Detroit  
Edison

Reference: Enrico Fermi Atomic Power Plant, Unit 2  
NRC Docket No. 50-341

Subject: 10CFR50, Appendix G & H  
Information Transmittal

Fermi 2 Reactor Vessel  
Beltline Plate and Weld  
Information

FERMI 2 BELTLINE PLATE AND WELD SEAM LOCATIONS

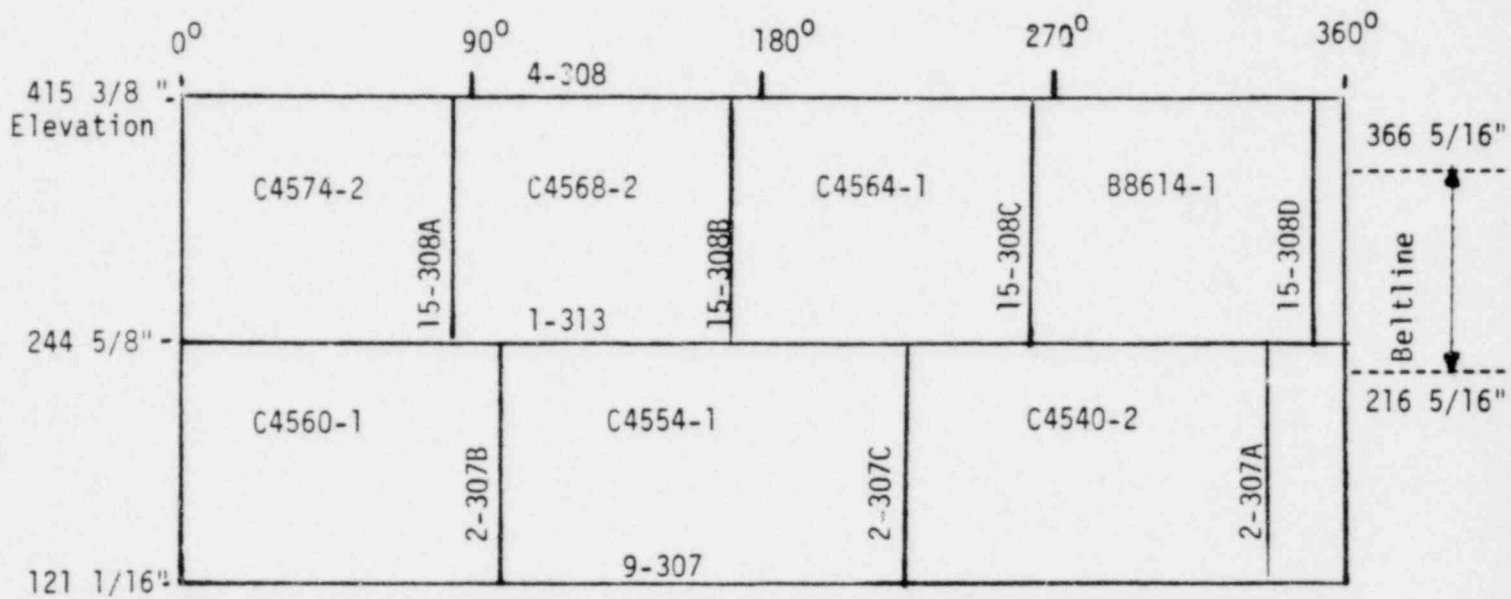
Question 121.23

A sketch of the beltline of the reactor vessel showing the location of all of the beltline plates and welds is shown in Figure 1. The azimuth angle giving the location of the capsules is given in the response to Question 121-24(c).
